July 26, 2022

I am writing in regard to the 40B project, Sanctuary by the Sea, being proposed by SLV School Street, LLC. First off, I would like to thank you and the Board for the incredible effort you have put forth in these months of review. That being said, there are so many problems with the proposed development. The three areas of the projects unsuitability I would like to point out fall into three main categories, safety, environmental impact, and constructability.

Snow Storage Plan 1

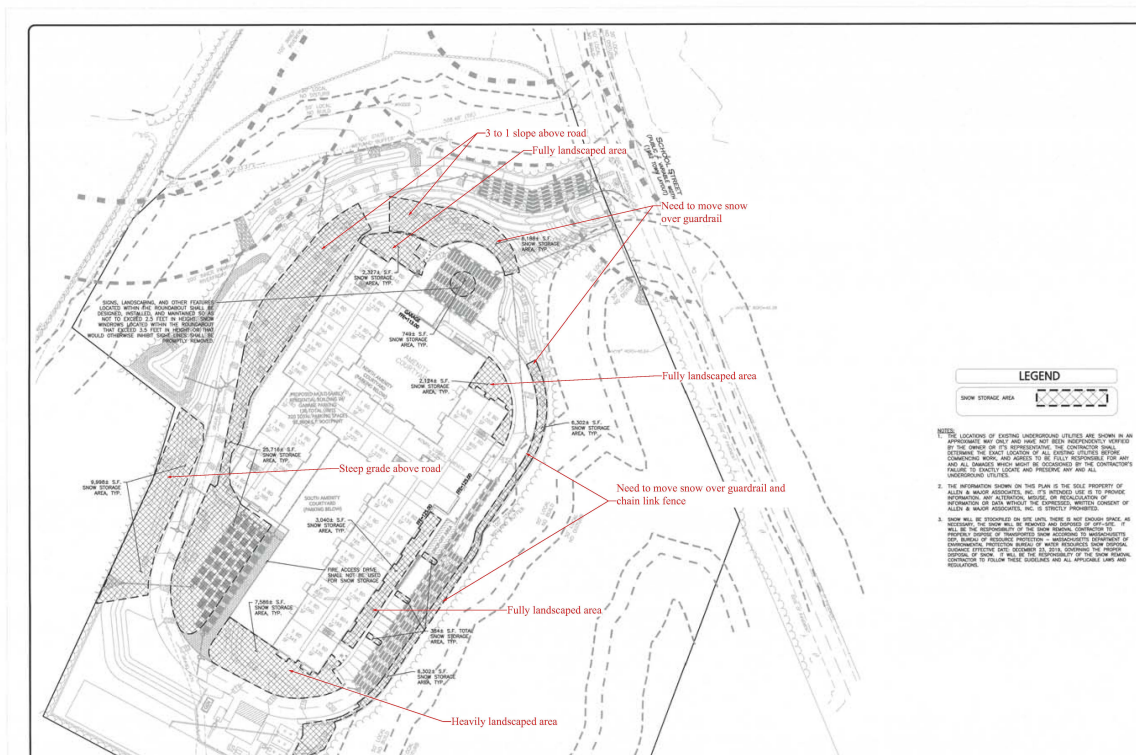
And speaking of snow, the snow storage plan presented by the applicant is laughable. They are showing snow storage on the 3:1 slope north and west of the building as well as in heavily landscaped areas. Along the east side of the building, they are showing snow storage on the other side of the guard rail, retaining wall, and 42" high chain link fence. How are they going to get it there?

Grading Plan

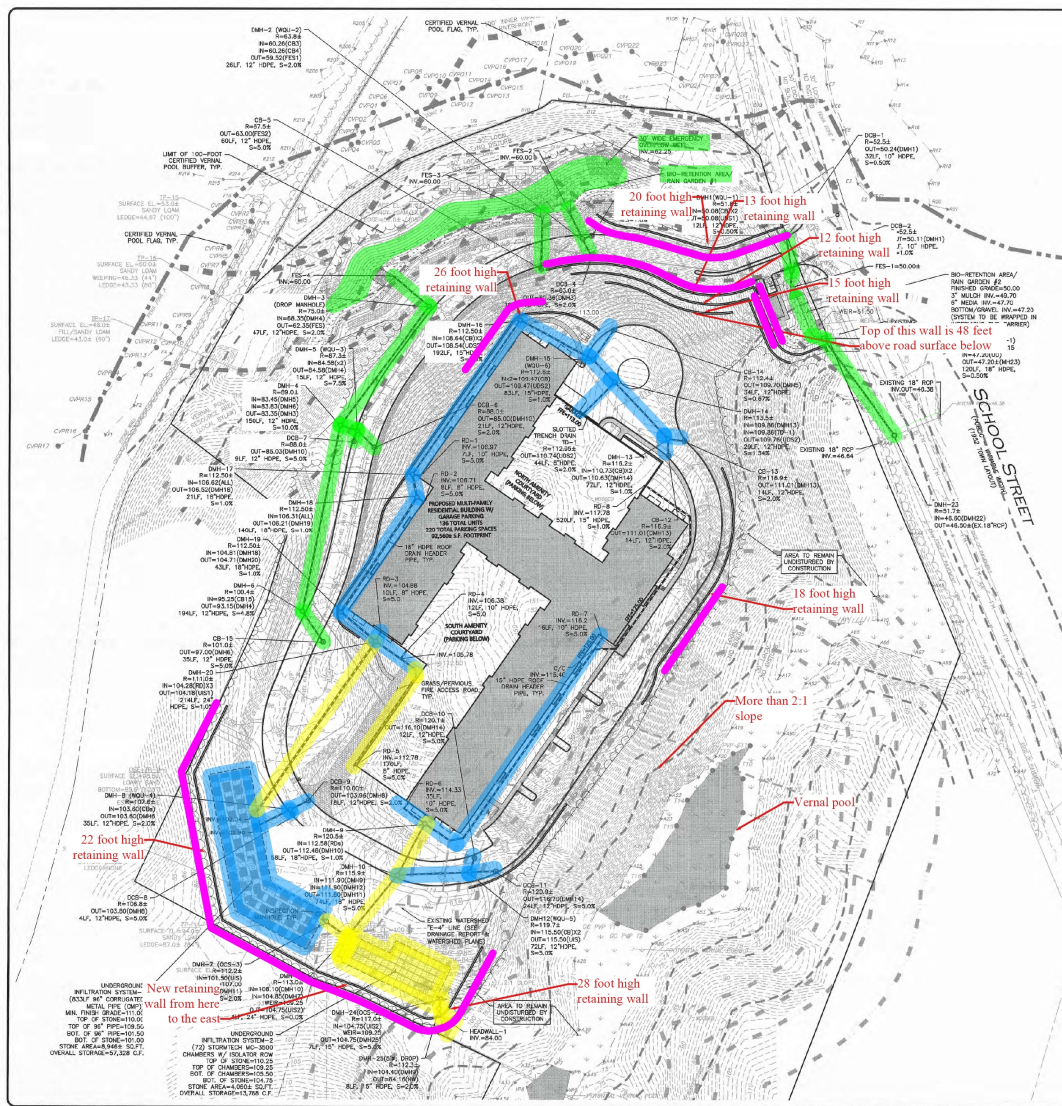
As Clifford Boehmer of Davis Square Architects said in his peer review, this project lacks "slack." That basically means there is no room to adjust if things do not go according to plan. One of the things the engineering plans do not show on their plans is where the bottom of the retaining walls land relative to their indicated tops. Because the developer has chosen to use a modular system for their retaining walls, the face has to have a slope or cant. This ratio will vary between different proprietary systems. Without knowing which system will be used, it is hard to quantify the horizontal projection of the wall at its base. Another factor in these systems is that they are typically reinforced with a geo grid which is a strong perforated composite fabric which is placed every few courses back into the hill side. Essentially this means one has to dig/blast a much larger excavation behind the wall. It is not knowing what is in that excavation that leads to

potential problems. And with no slack it is hard to adjust. On the attached Grading Plan from Allen & Majors, I have indicated in magenta lines off sets from the tops of portions of the highest retaining walls. Each magenta line represents the base of the wall immediately uphill from it. These are just rough estimates of how far from the tops of the walls the edge of the excavation for the walls' base would be. In the case of the retaining wall south of the building enclosing the infiltration system there, it seems very possible the structure may well cross the property line. But even if it does not, it would be difficult to build this wall without access to the neighbor's property. And pity the poor neighbor who has to look at a 22-foot-tall retaining wall on their lot line! In addition, the limit of work line indicated on the plan should be expanded to accommodate the reality of building these walls. On the plan, the green highlight represents all the storm water being directed to the raingarden to the north and to the culvert under School Street. The blue highlight represents the storm water being directed to the infiltration system south of the building. The yellow highlight represents the change from the previous drainage plan of 3-23-22. And again, the magenta lines represent the edge of the retaining walls' base.
